Access Compliance Report

Public Rights-of-Way

Intersection ID: 7435	Main Street: CLAREMONT_RD	Cross Street: STONEHURST_DR	Location:	N/A
ADA ID: 7DC777B08977	Ramp Type: Perp	Initial Pass/Fail: Fail	Overall Compliance: No	Severity Score: 10

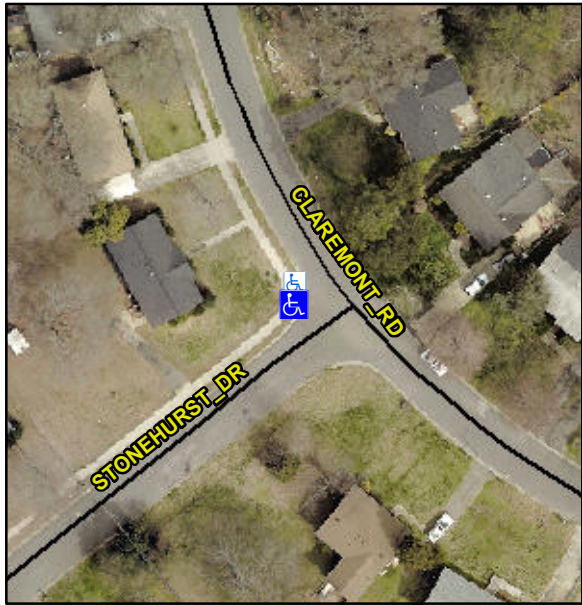
Codes/Mitigation Info/Possible Solution			Field Measurements/Component Compliance					
	Possible Solutions:		Compliance	Description	Data	Compliance	Description	Data
	Remove & Replace Entire Ramp.		N/A	Ramp Length (in)	48.0	Yes	Ramp Slope (%)	6.0
			No	Ramp Width (in)	47.5	No	Ramp XSlope (%)	4.2
			N/A	Flare Type LT	N/A	N/A	Flare Type RT	N/A
			N/A	Flare Slope LT (%)	N/A	N/A	Flare Slope RT (%)	N/A
			N/A	Flare Traversable LT?	N/A	N/A	Flare Traversable RT?	N/A
			N/A	Landing Length (in)	N/A	N/A	DWS Provided?	N/A
			N/A	Landing Width (in)	N/A	N/A	DWS Contrast?	N/A
			N/A	Landing Slope (%)	N/A	N/A	DWS Length (in)	N/A
			N/A	Landing X Slope (%)	N/A	N/A	DWS Full Width?	N/A
Surveyor Notes:	N/A		N/A	Landing Curb? (Y/N)	N/A	N/A	DWS Offset (in)	N/A
			N/A	Shared Landing?	N/A			
	PROW/ADA:		N/A	Gutter Ponding?	N/A	N/A	Gutter Slope (%)	N/A
	Not Found, R304.5.1, R304.5.3		N/A	Gutter Lip Ht (in)	N/A	N/A	Gutter X Slope (%)	N/A

N/A	Painted X Walk1?	No	N/A	Painted X Walk2?	N/A
				X Walk 1 Direction	To S		X Walk 2 Direction	N/A
			N/A	X Walk 1 Width (in)	N/A	N/A	X Walk 2 Width (in)	N/A
				X Walk 1 Slope (%)	4.0		X Walk 2 Slope (%)	N/A
				X Walk 1 X Slope (%)	3.5		X Walk 2 X Slope (%)	N/A
			N/A	Ramp inside XWalk1?	N/A	N/A	Ramp inside XWalk2?	N/A
Street 1 Name Stop Condition-Street 2 Street 2 Name Stop Condition-Street 1	STONEHURST DR StopSign N/A N/A			Road Slope (%)	3.5	N/A	Clear Space?	N/A
				Road X Slope (%)	4.0	N/A	Clear Space to XWalk (in)	N/A
			N/A	Any Obstructions?	N/A	N/A	Storm Grate/Utility Hazard?	N/A
				Obstruction Type			Storm Grate/Utility Type	
					N/A			N/A
						Yes	Surface Condition? (G/P)	Good
	Total Cost:		\$	1850.00
